## ADDENDUM NO. 1

Board of Education – New Parking Lot

San Bernardino City Unified School District

RCA Project No. 1-78-60

LP-1.0

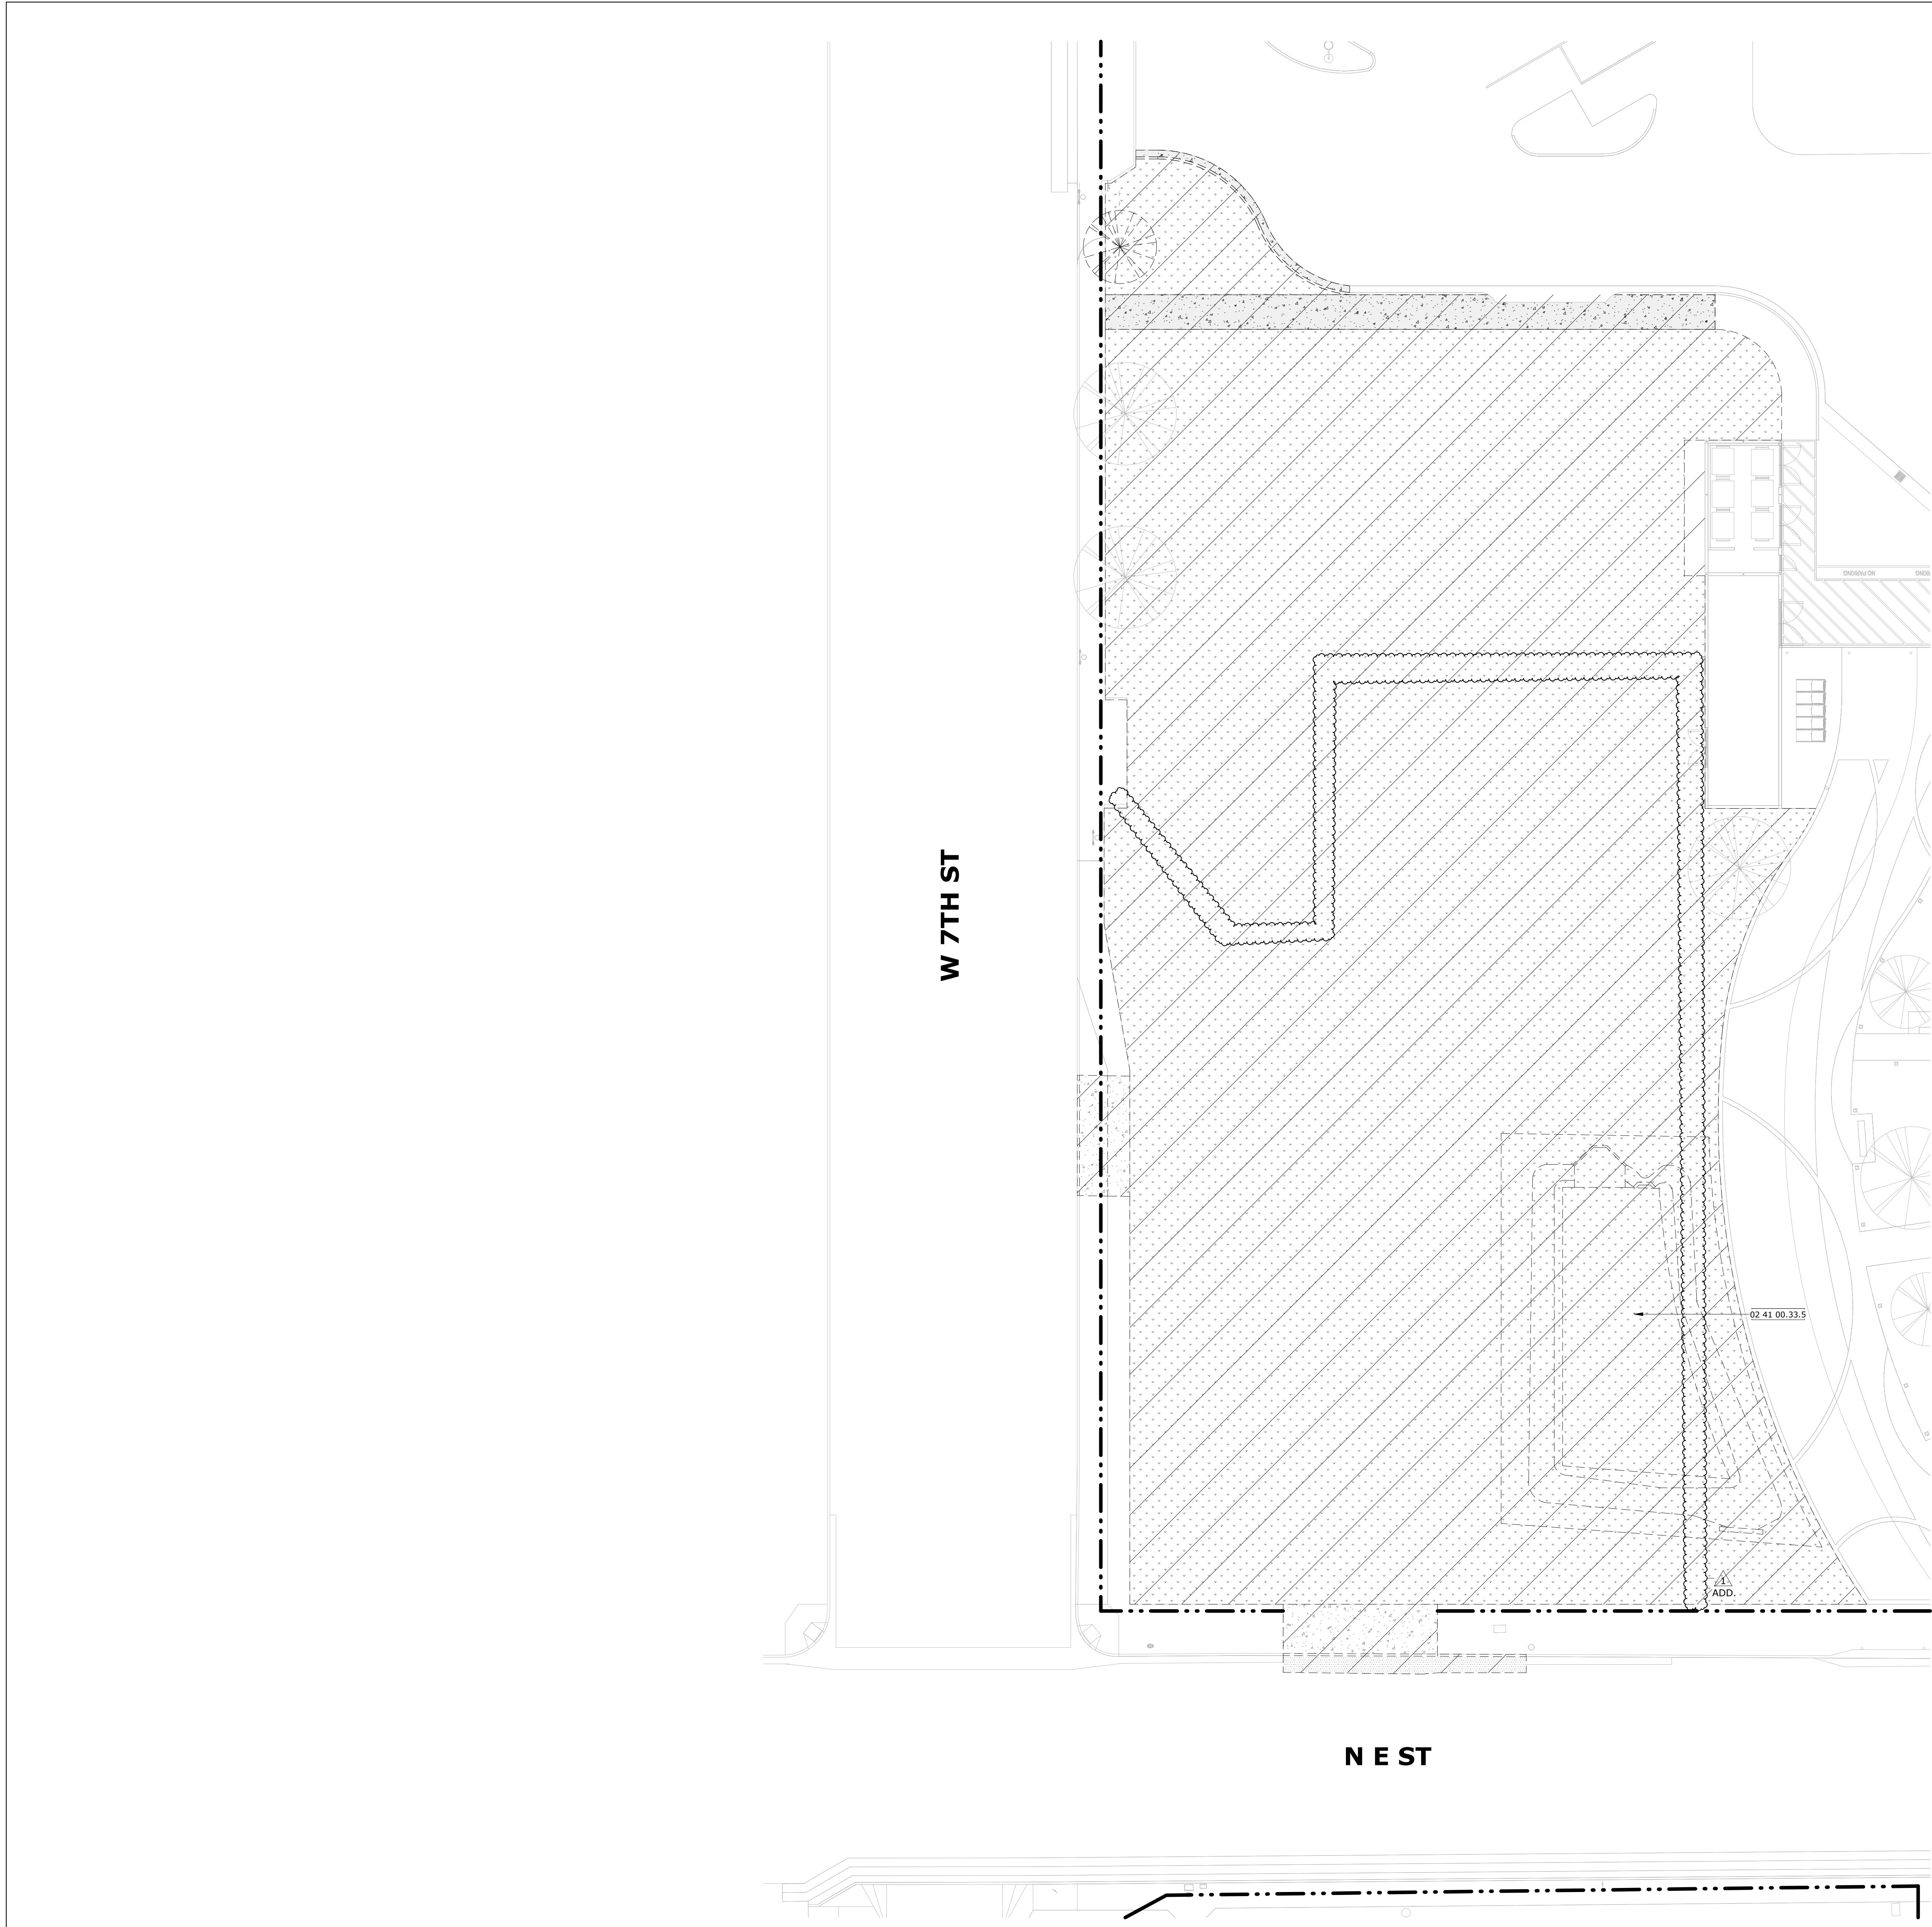
Item No. 1.9      New Sheet LP-1.0 – LANDSCAPE CONCEPT PLAN

## AS-2.0

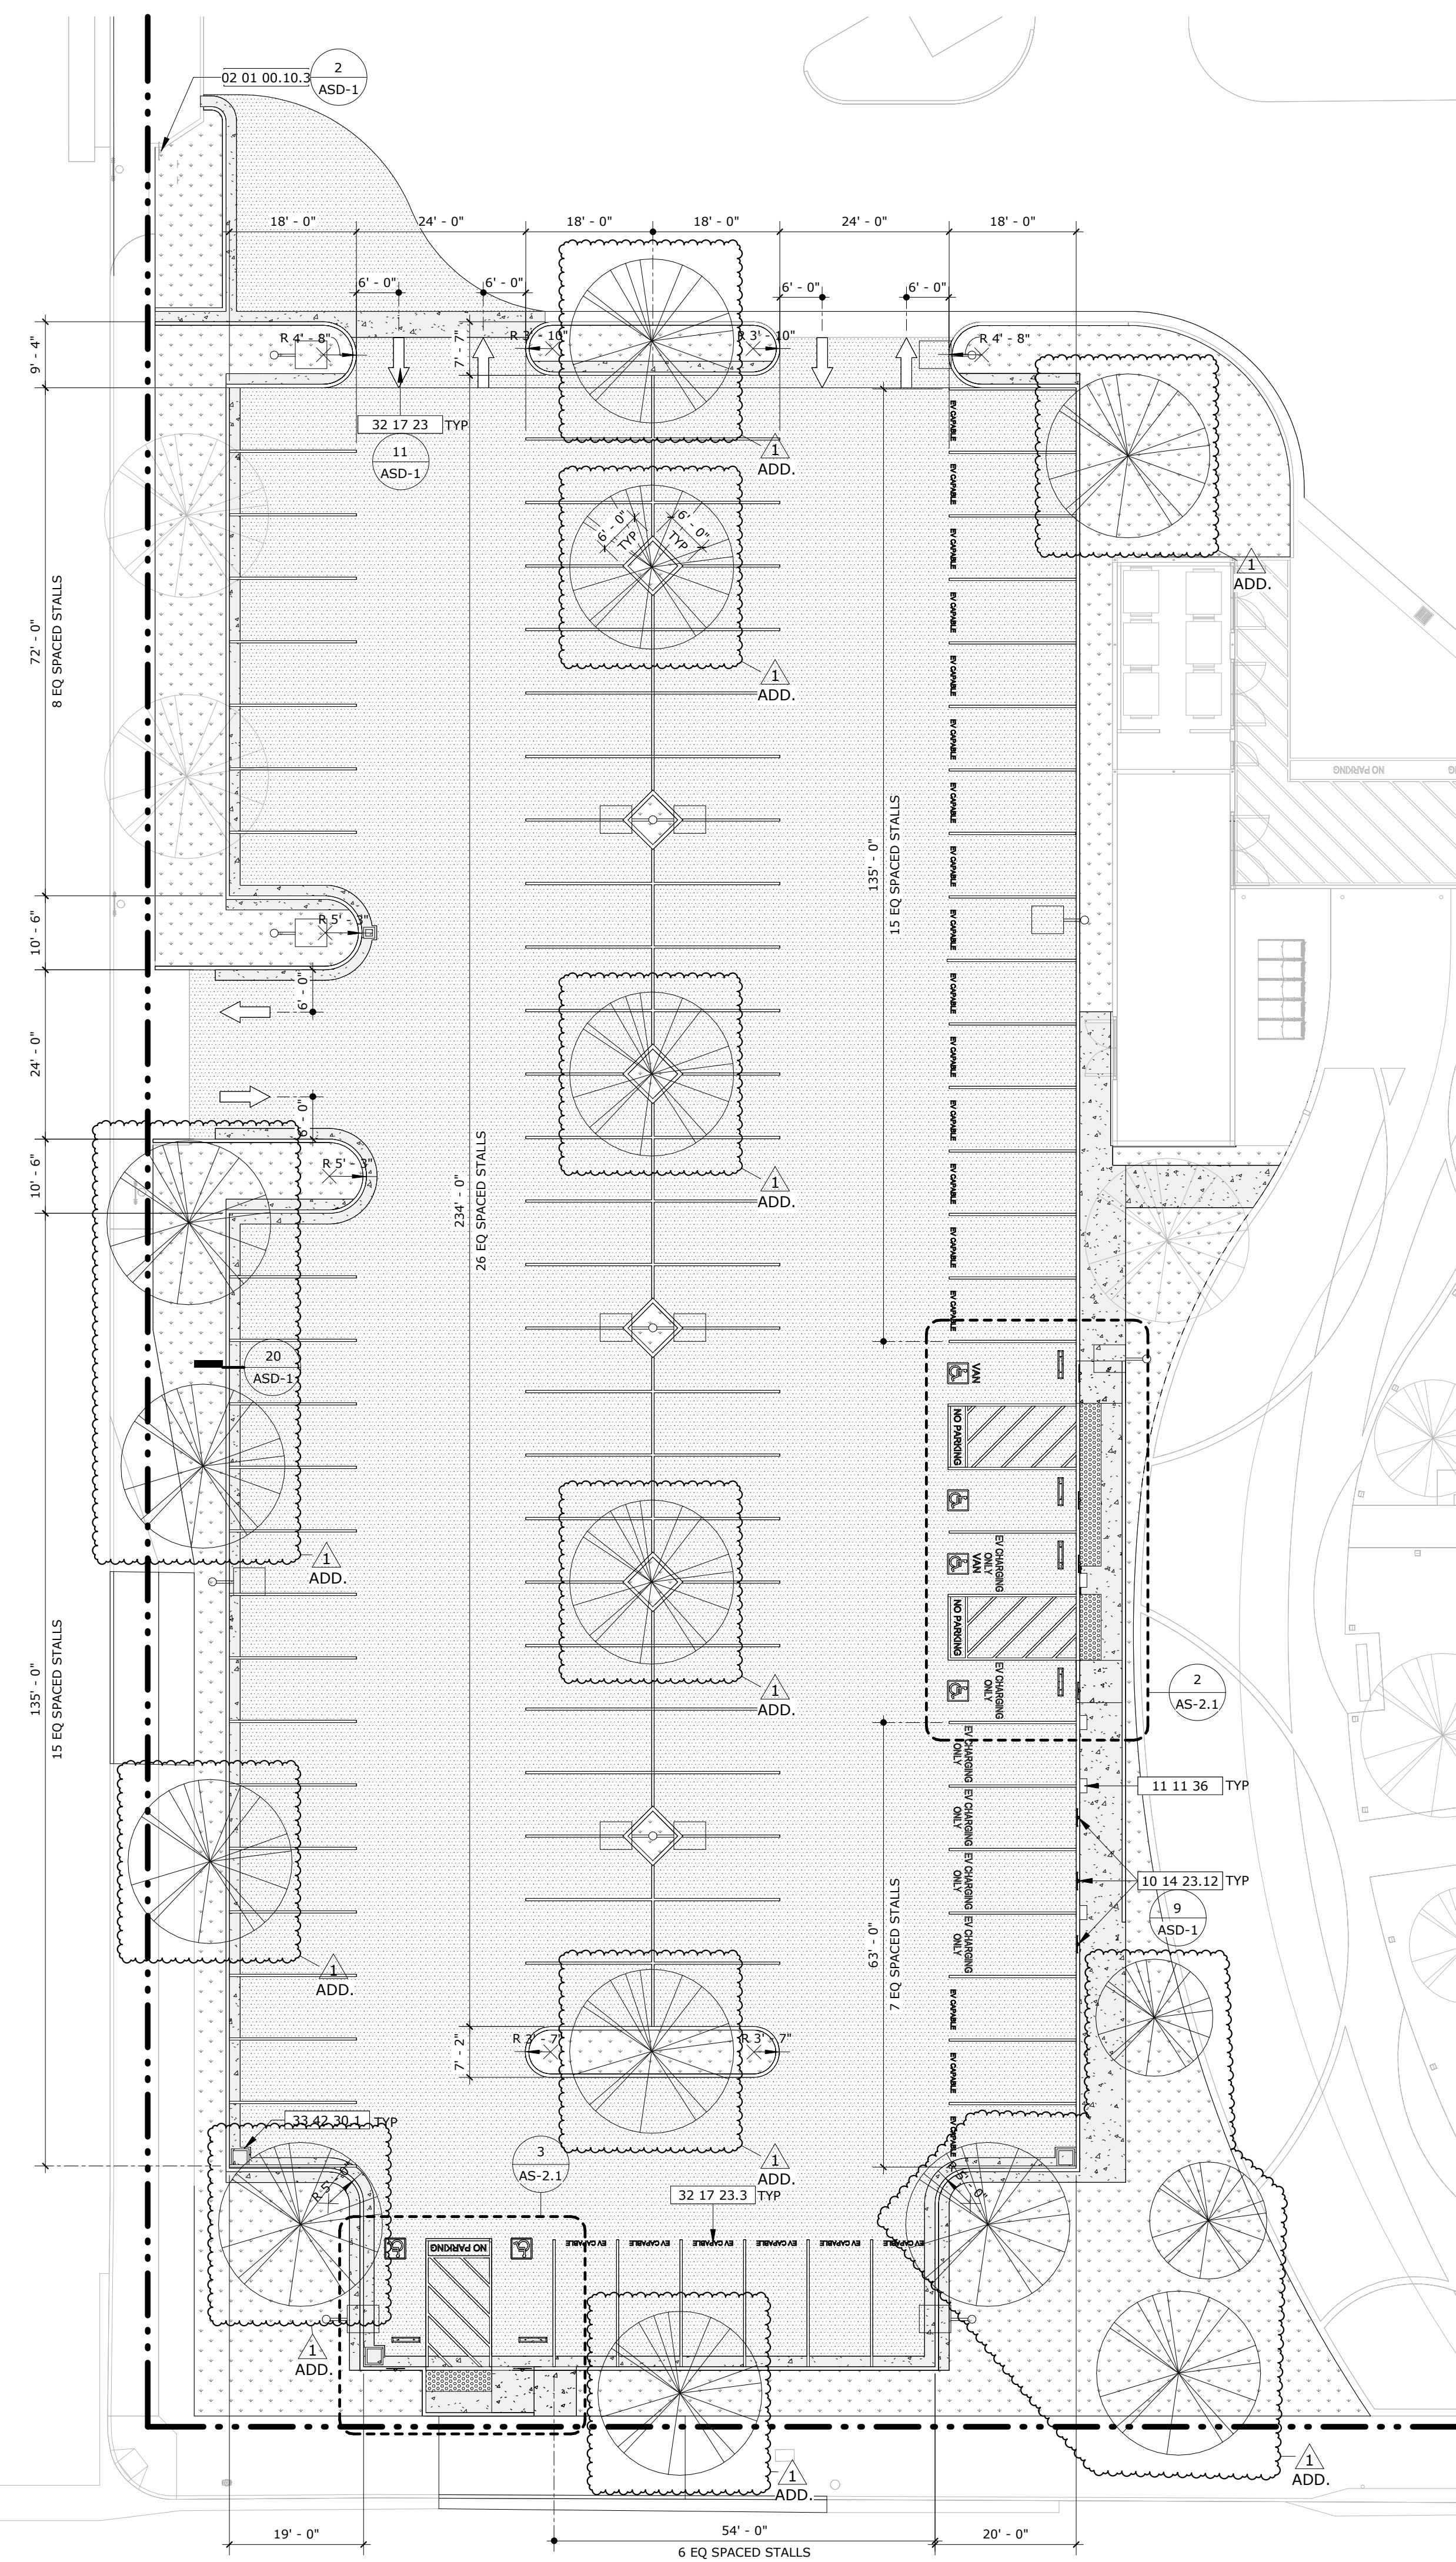
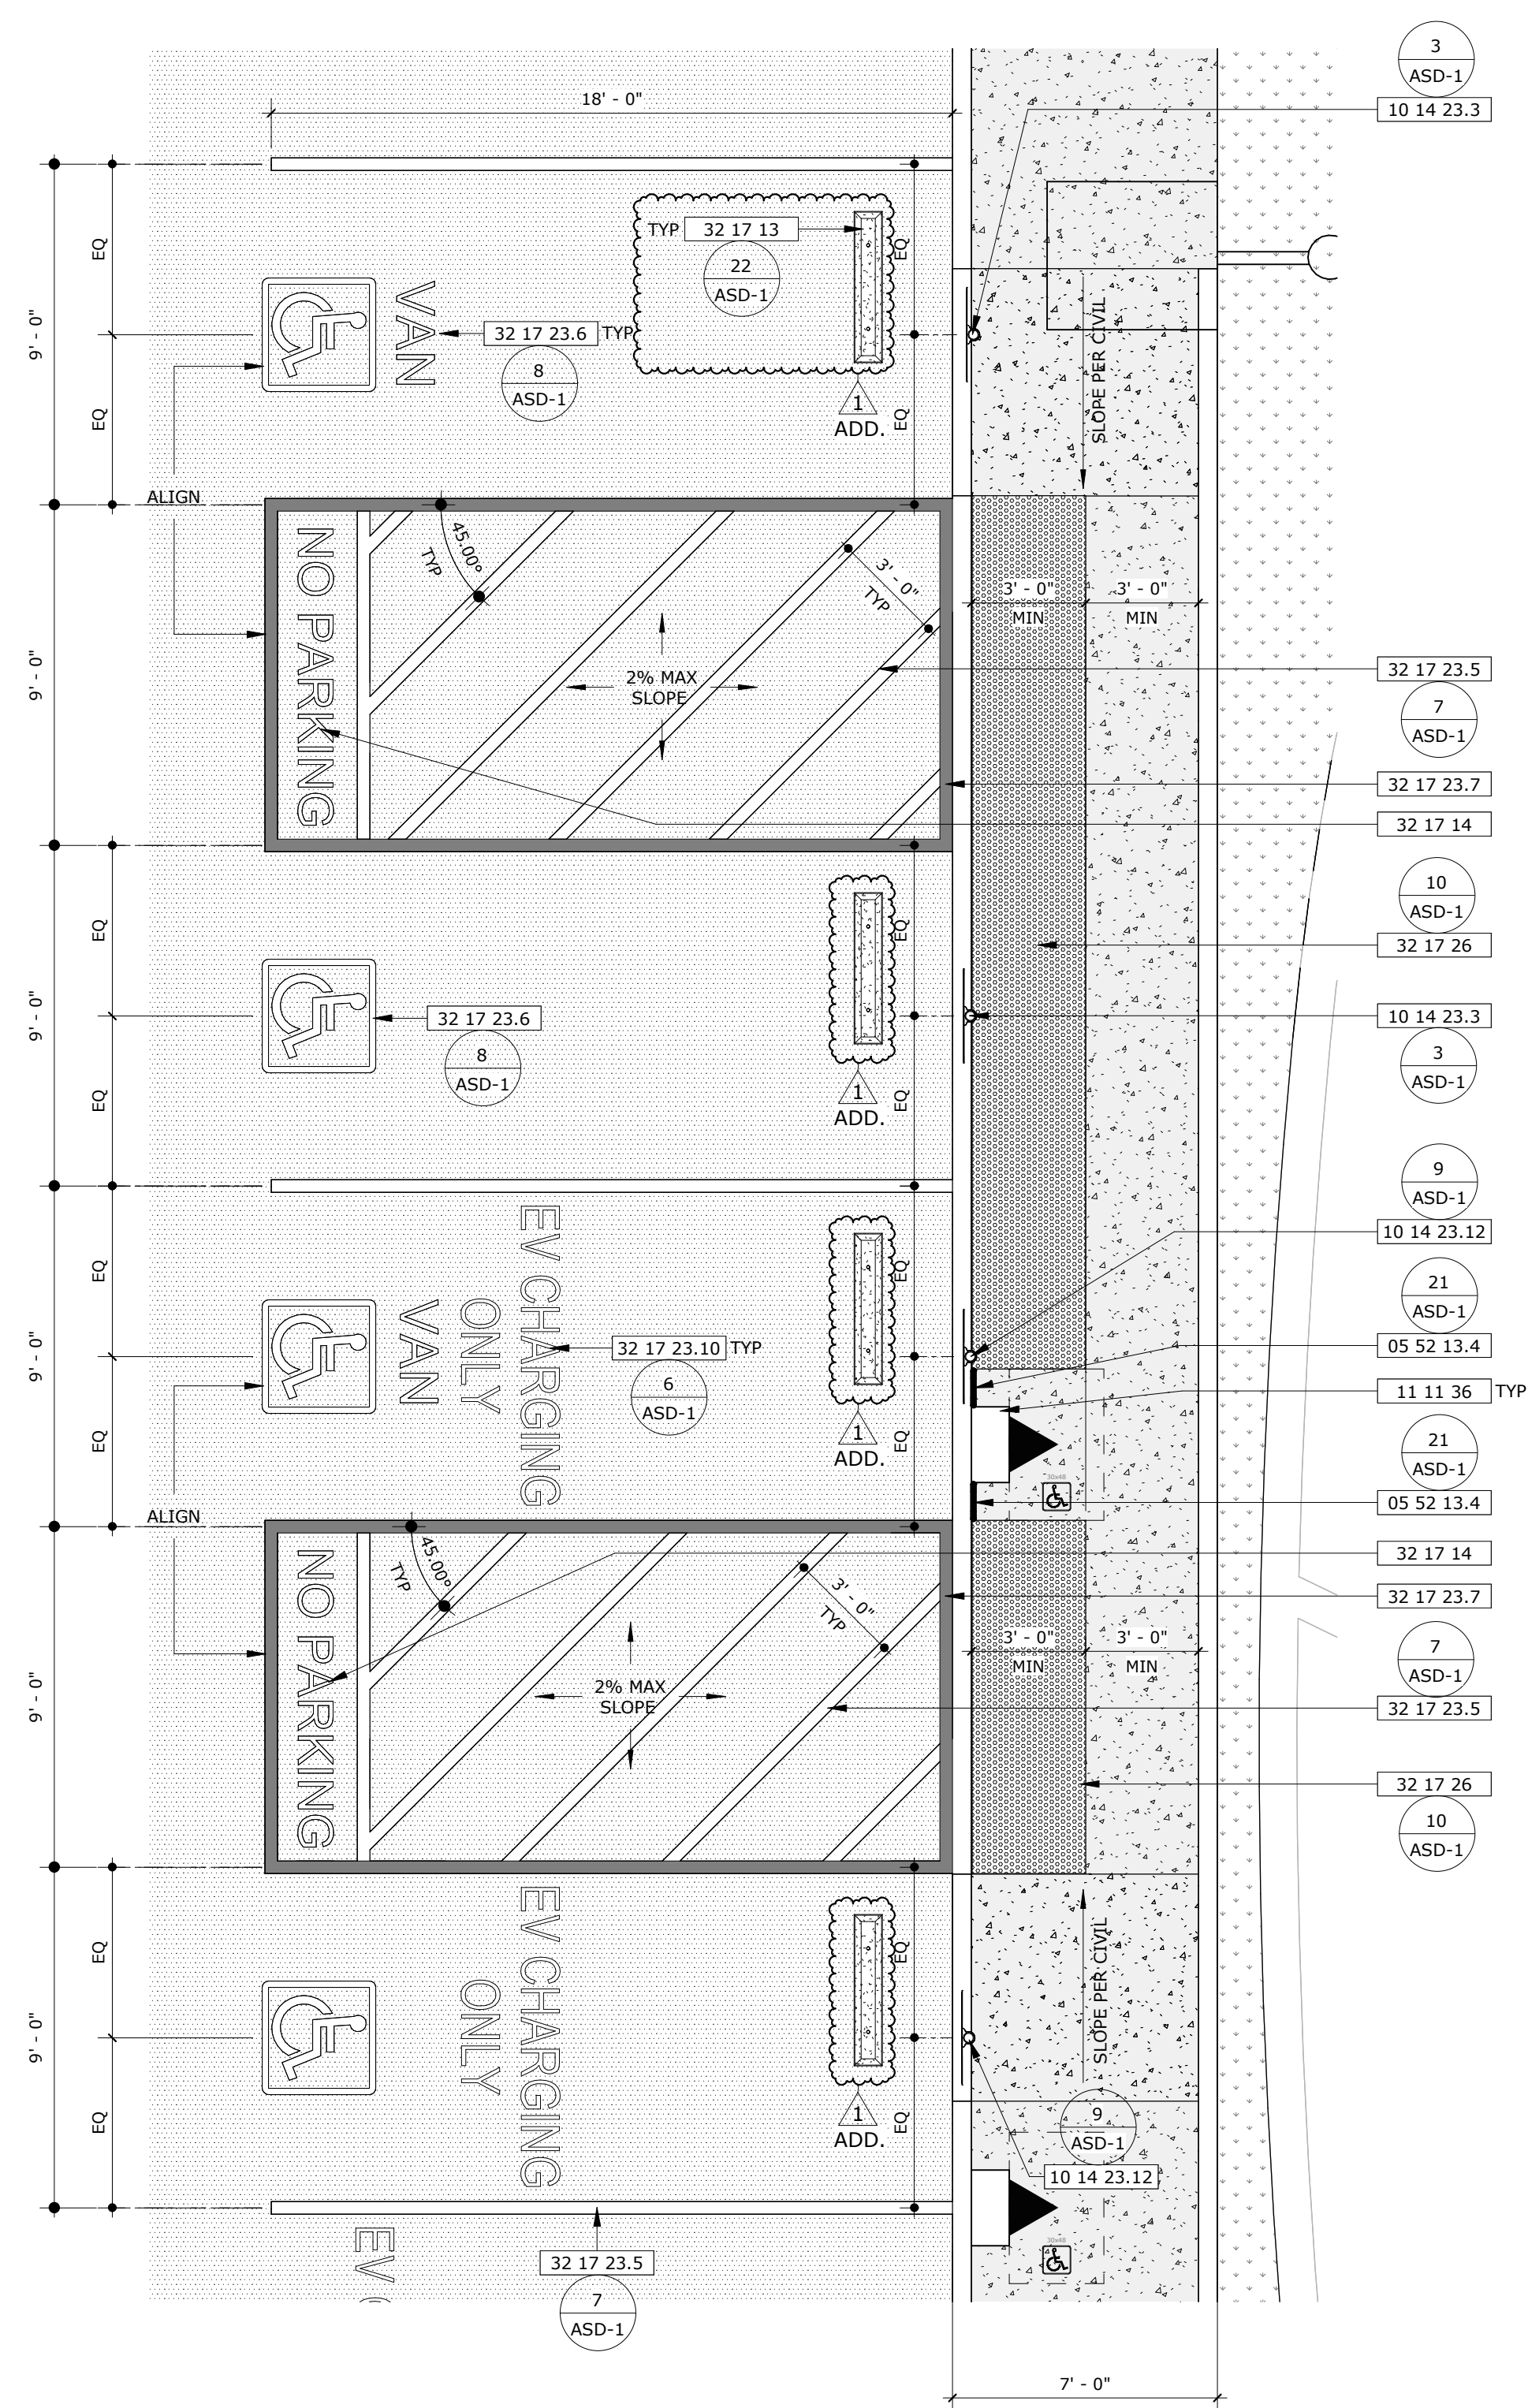
Item No. 1.11     Reference Sheet AS-2.0 – OVERALL SITE PLAN  
                   1.11.1    Replace Sheet AS-12.0 and revise per clouded areas listed below:  
                           (a)    Updated per landscape plan.  
                           (b)    Added wheel stops as shown.  
                           (c)    Provided additional dimensions for clarity.  
                           (d)    Removed text markings for EV capable stalls.
